| Letter                    | Particulars of Amendment  | Date    | Initials |
|---------------------------|---|---------|----------|
| FORMERLY DRG. 10800.      |   |         |          |

MATERIAL. Copper, 0-008" approx thickness.

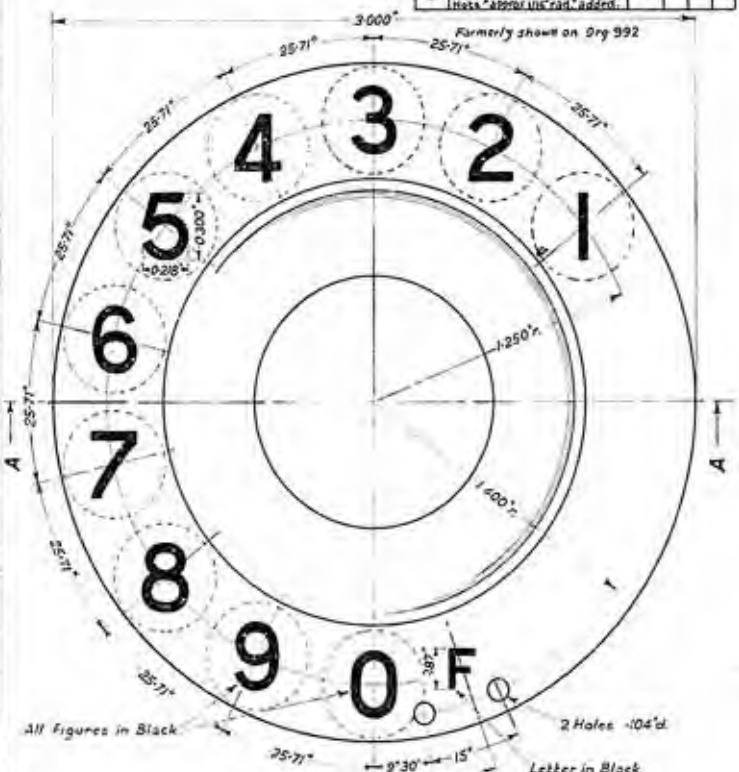
| Letter                    | Particulars of Amendment  | Date    | Initials |
|---------------------------|---|---------|----------|
| B                         | Holes .104" dia. 4.943" w/d 4.<br>Dim. 1.200" w/d 1.042".<br>Hole "approx 115" rad." added. | 1/22/33 | W.C.     |
